October 19, 2017

CASE # V 17-5200 W. Gordon Harris Variances

W. Gordon Harris, Applicant, Sommer, Karnes & Associates, LLP, Agent, request a variance of Ordinance No. 2016-9, the Sustainable Land Development Code Chapter 7, Section 7.11 Road Design Standards, Table 7-13 Rural Road Classification and Design Standards (SDA-2 and SDA-3) to allow a roadway to be less than 20' in width and to allow the roadway to exceed a 9% grade. An additional variance is being requested of Chapter 7, Section 7.17.9.3 Height to exceed thirty feet on land that has a natural slope of fifteen percent or greater.

HARRIS RESIDENCE

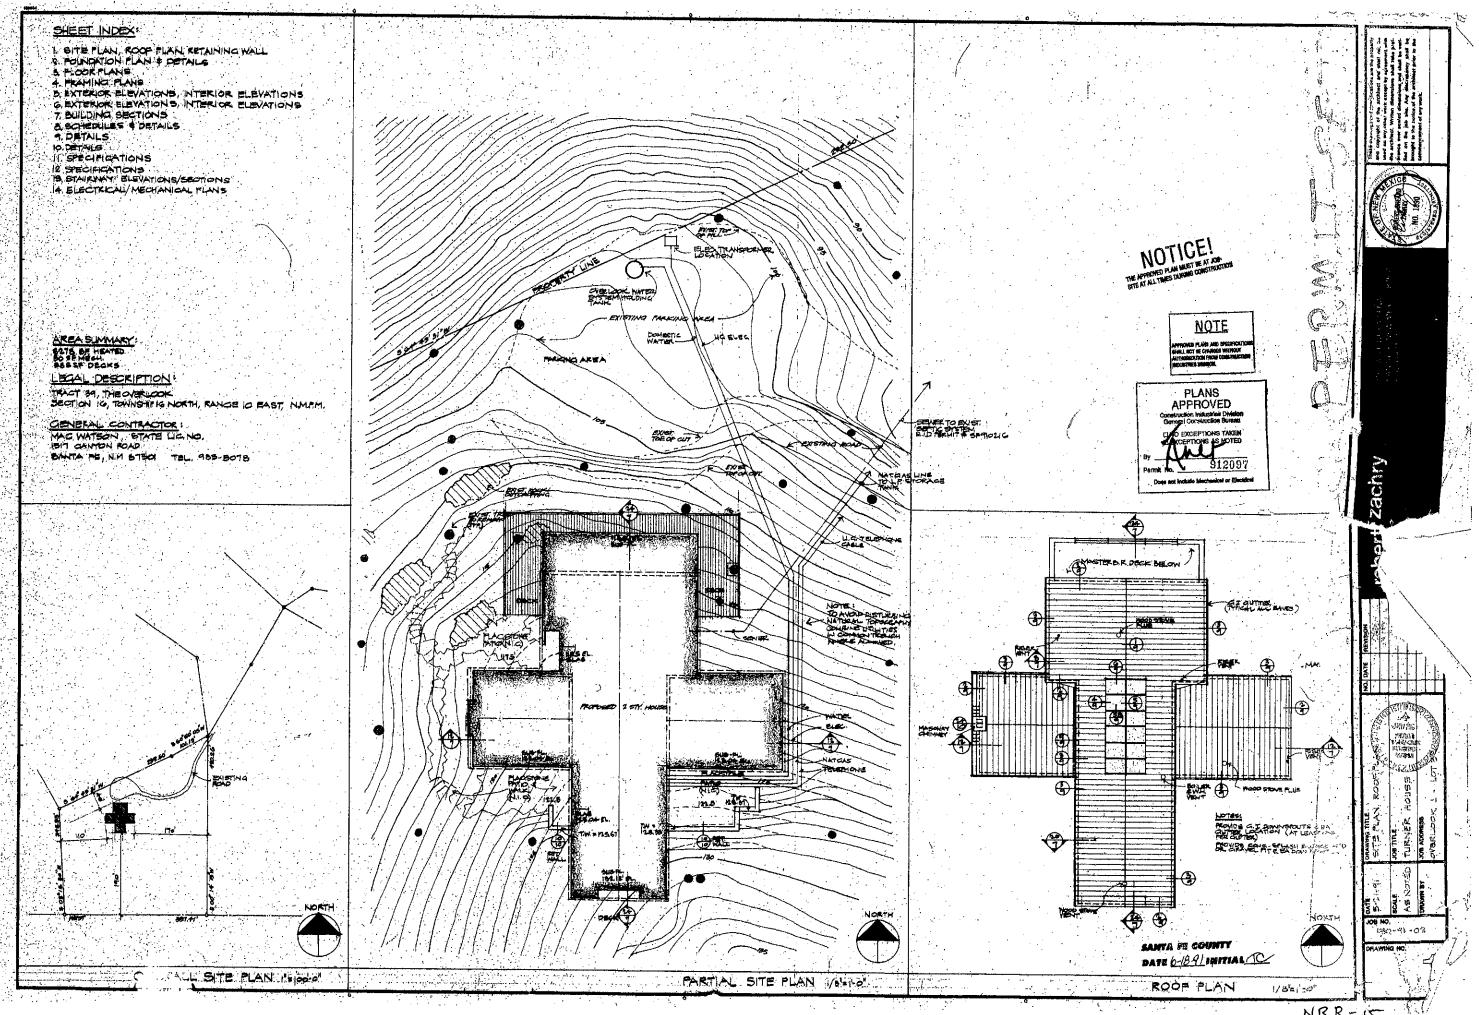
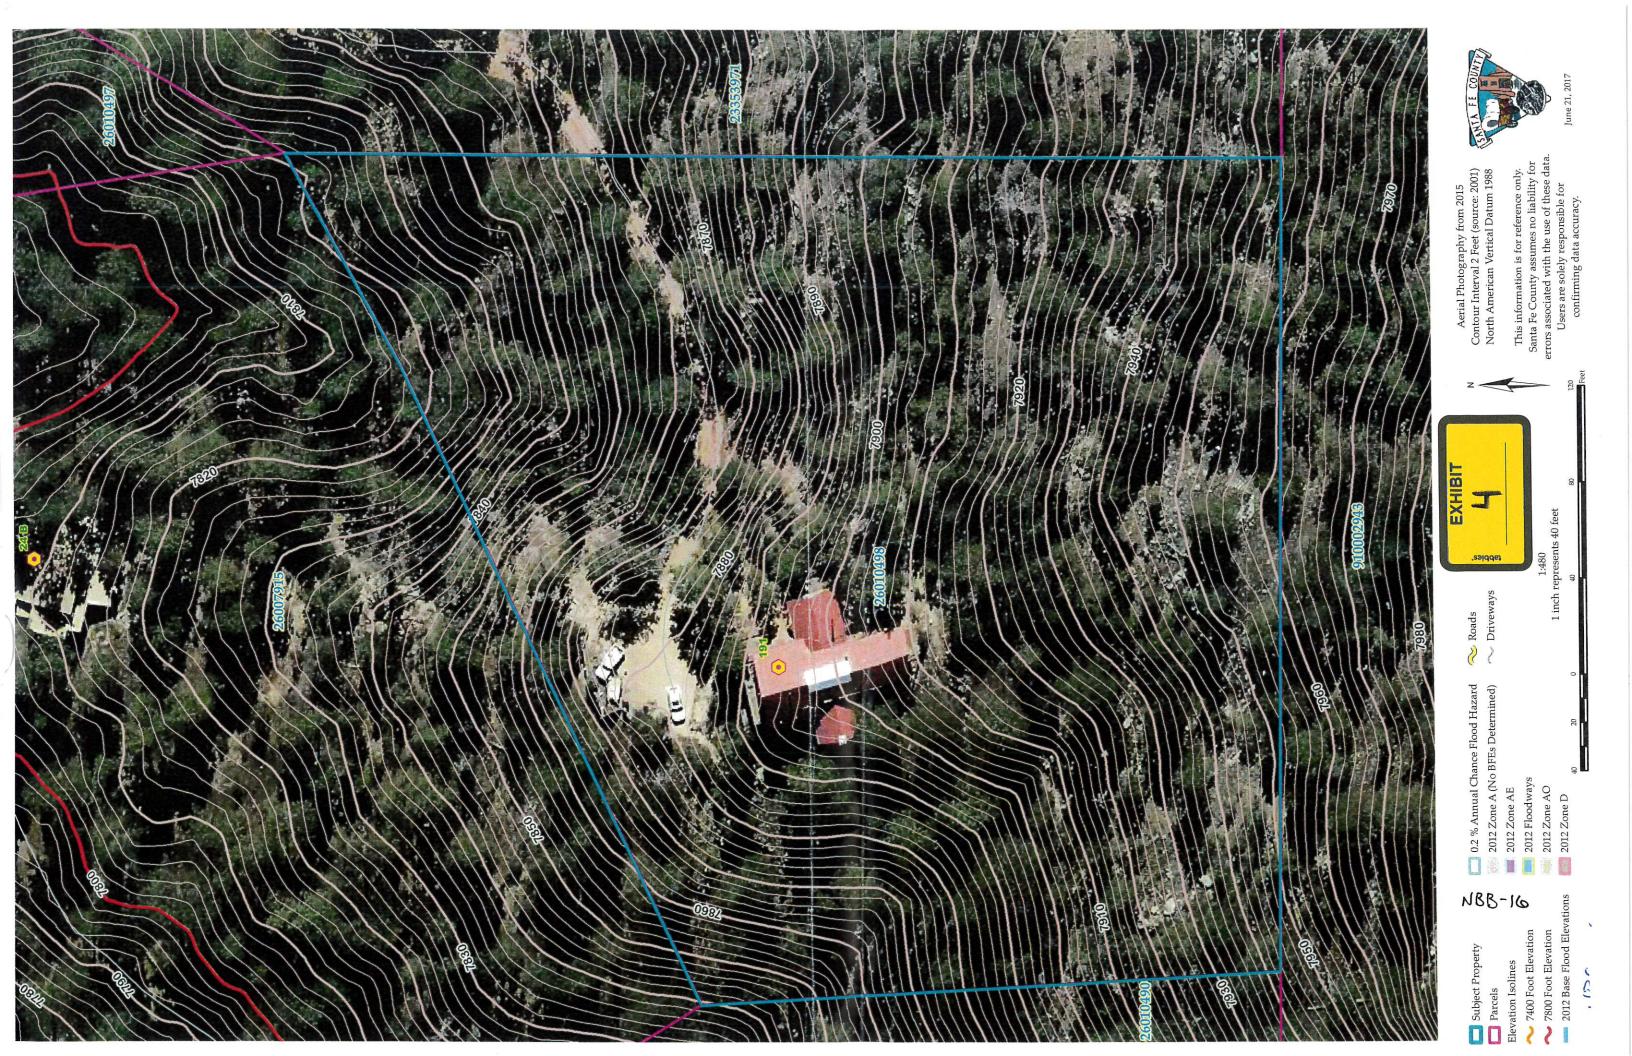
Full view from the Northern elevation of the residence would be 43'11" instead of the 30' allowed by Code. The location for the proposed garage would increase visibility by nearly 14'.

Here's the existing house, the high point of the house is not going to change. What's going to add the additional height is adding the garage at the bottom here, so that it goes from 36 feet 7 inches to 43 feet 11 inches because it's here at the bottom. But the point is that with trees all along here, and I have some photos that I can show you from a distance, that adding this garage does not increase the visibility of the house.

Staff recommends denial of a height variance to exceed thirty feet on land that has a natural slope of 15% or greater and recommends that the Applicant construct an unattached garage which would not require a variance.
